BELFORD AVENUE OVER HAPPY CANYON CREEK  
72'30"00" SKEW (TO LAYOUT LINE)  
74'-0" ROADWAY WIDTH, EDGE OF SIDEWALK  
TO EDGE OF SIDEWALK (ULTIMATE)  
8'-6" SIDEWALKS

Print Date: 11/18/2016 8:09:49 AM	Sheet Revisions				As Constructed	BELFORD-HAPPY CANYON CREEK BRIDGE		Project No./Code
File Name: B115360-01INF01.dwg	Date	Comments	Initials		No Revisions:	GENERAL INFORMATION		
Horizontal Scale: VARIES Vertical Scale:				Revised:	Designer: J. LYNCH	Structure Numbers		
				Void:	Detailer: C. MIYAMOTO			
6300 South Syracuse Way, Suite 600 Centennial, CO 80111 tel 303.721.1440 fax 303.721.0832					Subset: BRIDGE	Sheets: B1 of 32		Sheet Number 11

**BELFORD-HAPPY CANYON CREEK BRIDGE**  
**SUMMARY OF QUANTITIES**

As Constructed	BELFORD-HAPPY CANYON CREEK BRIDGE		Project No./Code
No Revisions:	GENERAL LAYOUT (1 OF 2)		
Revised:	Designer: J. LYNCH	Structure Numbers	Sheet Number 13
Void:	Detailer: R. DILLON	Sheets: B3 of 32	
	Subset: BRIDGE

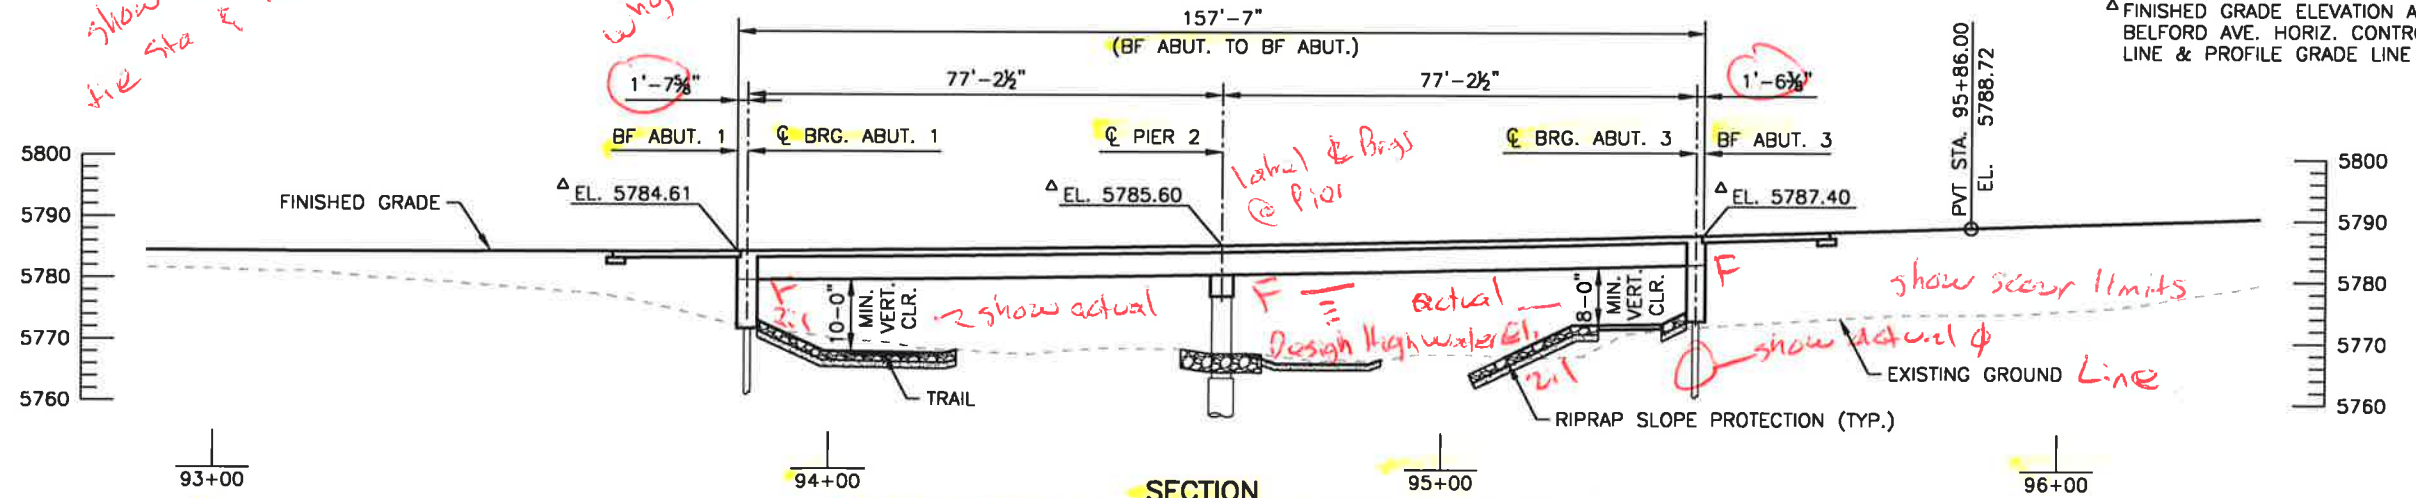
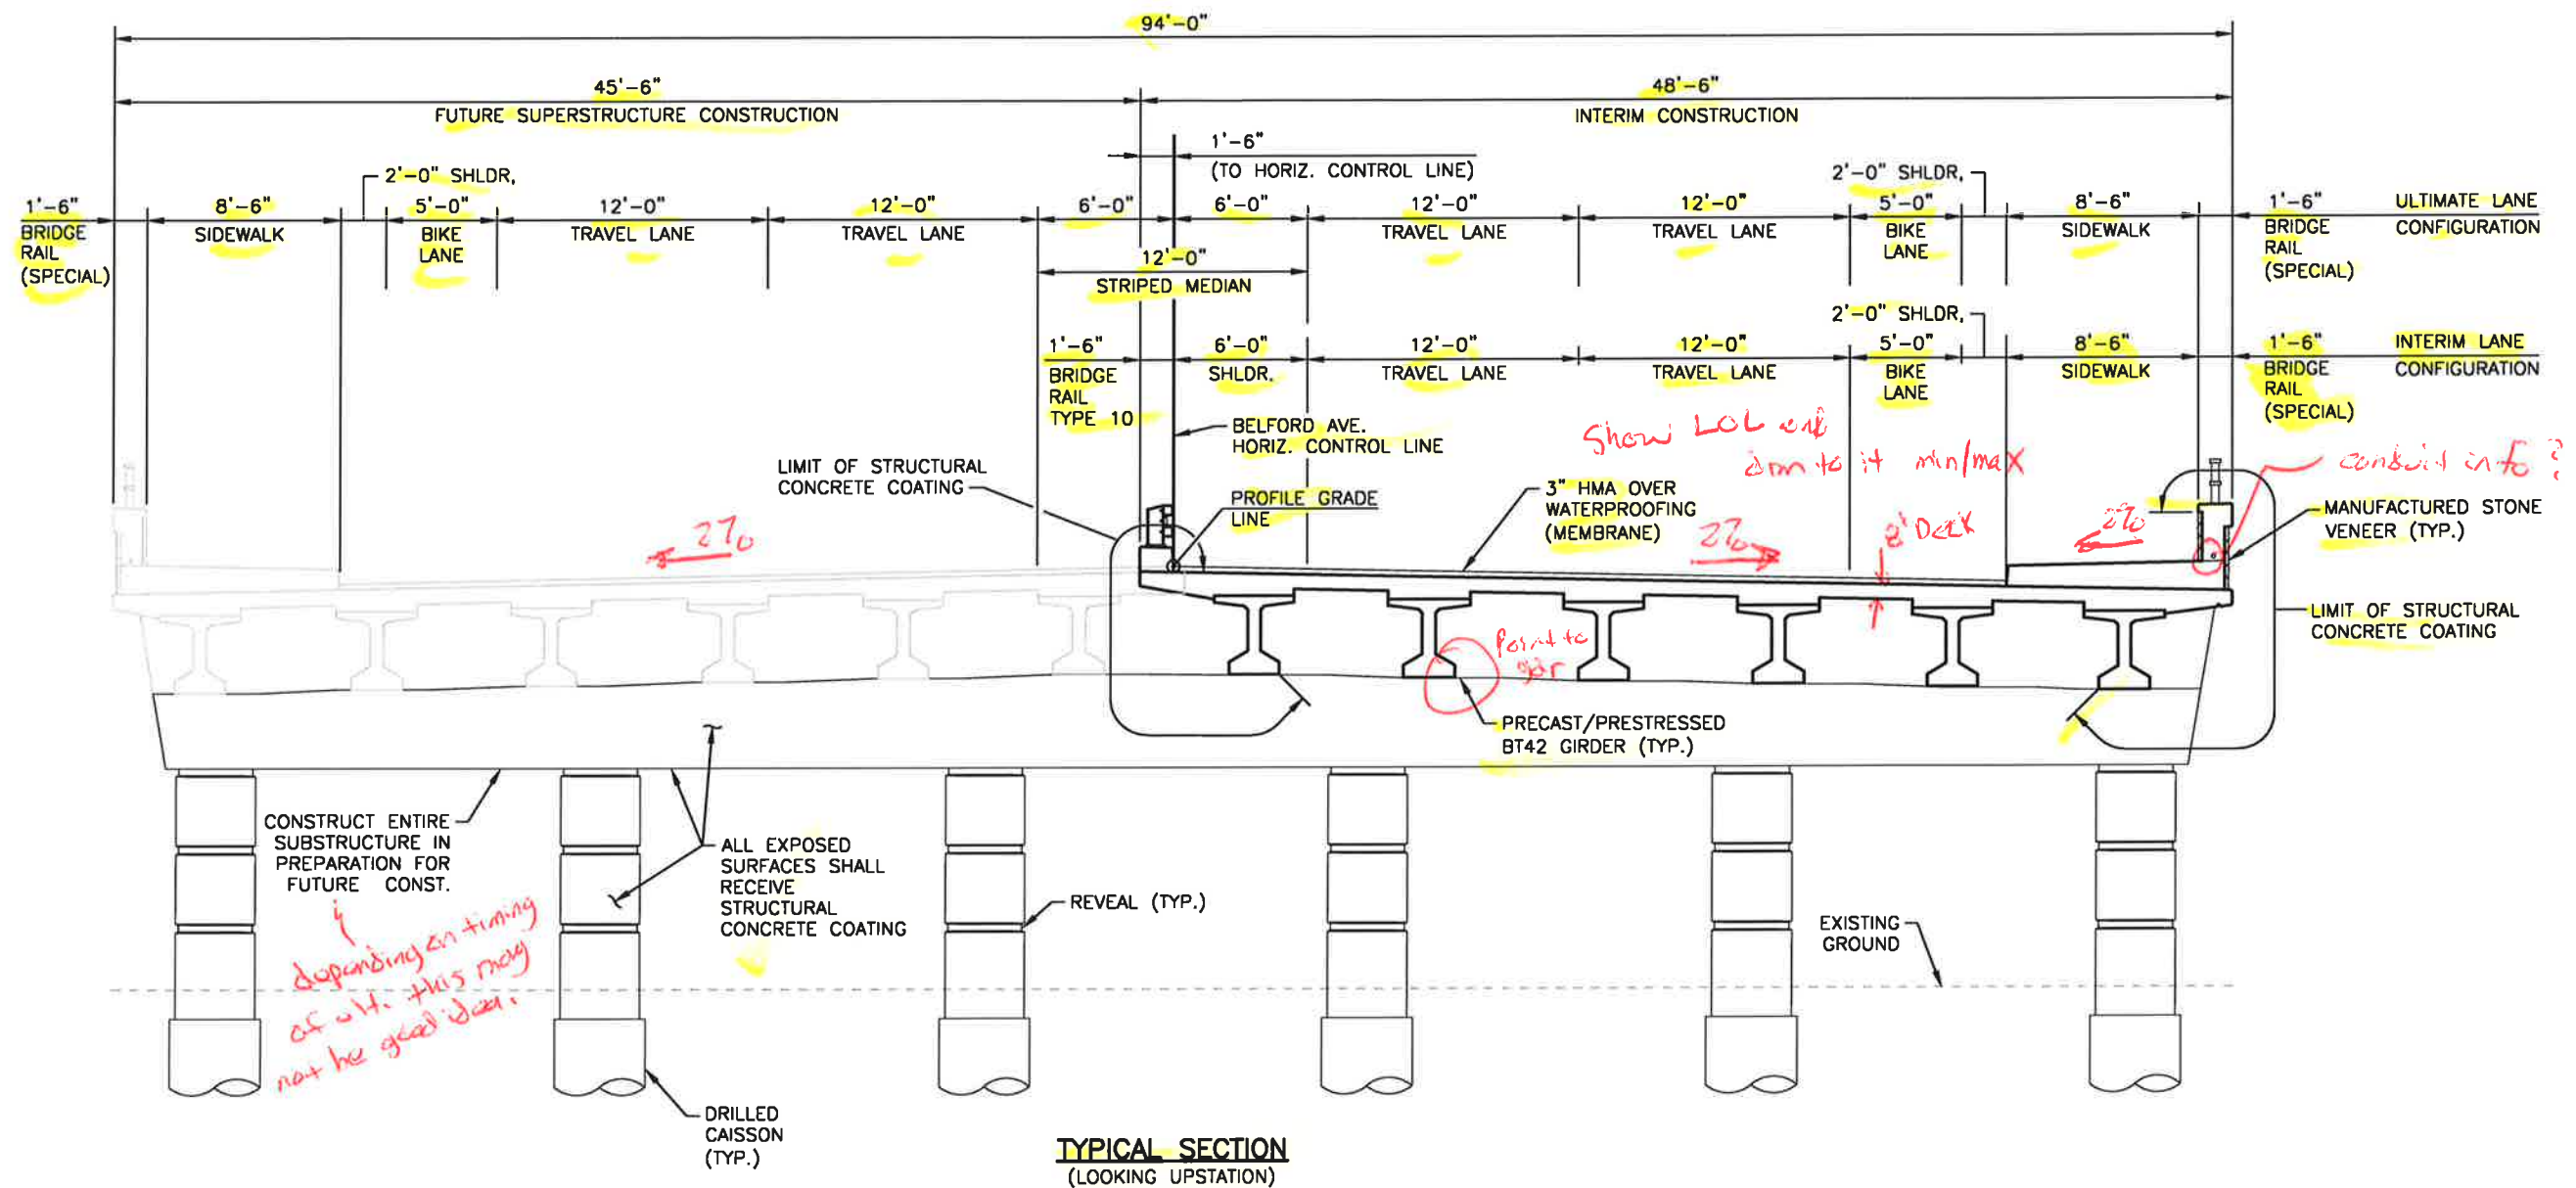
*Clean up lines thru text*

*Why no approach slab drains? on low end of B4 on high end*

*show trail & road tie sta & HCL*

*why different?*

As Constructed	BELFORD-HAPPY CANYON CREEK BRIDGE		Project No./Code
No Revisions:	ENGINEERING GEOLOGY		
Revised:	Designer: J. LYNCH	Structure Numbers	
Void:	Detailer: R. DILLON	Sheets: 85 of 32	Sheet Number 15

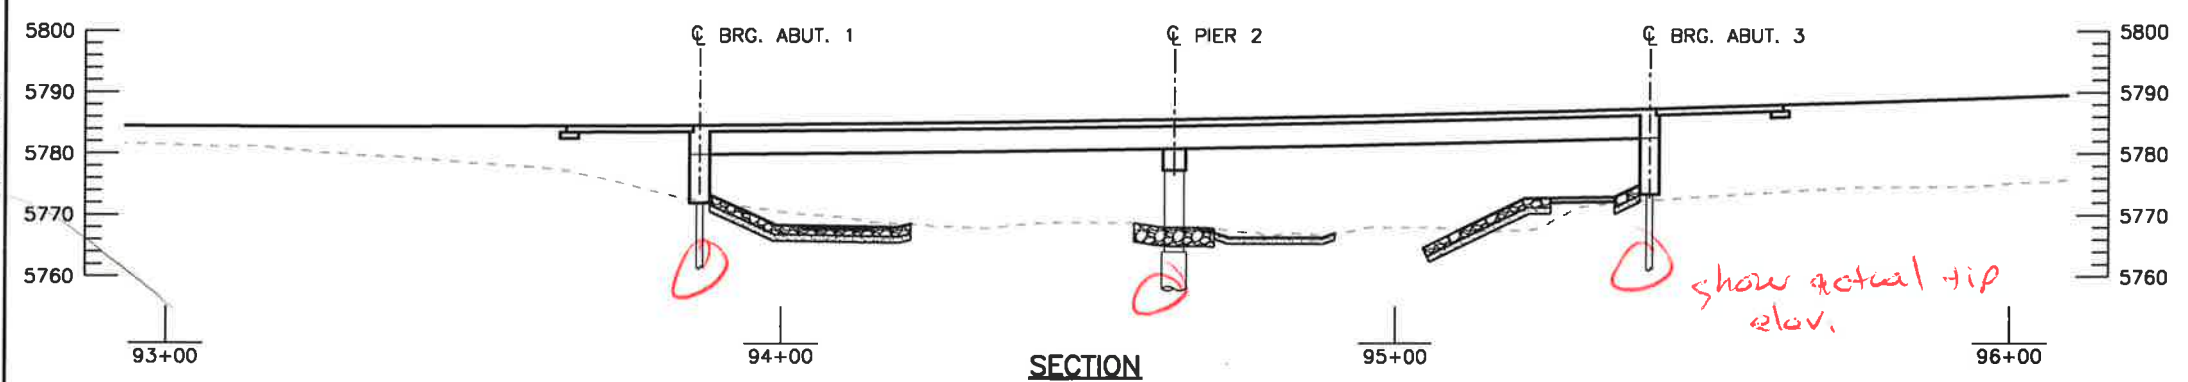
*No bearing info provided  
locations in plan, elev.  
test data, mat'l type, Legend*
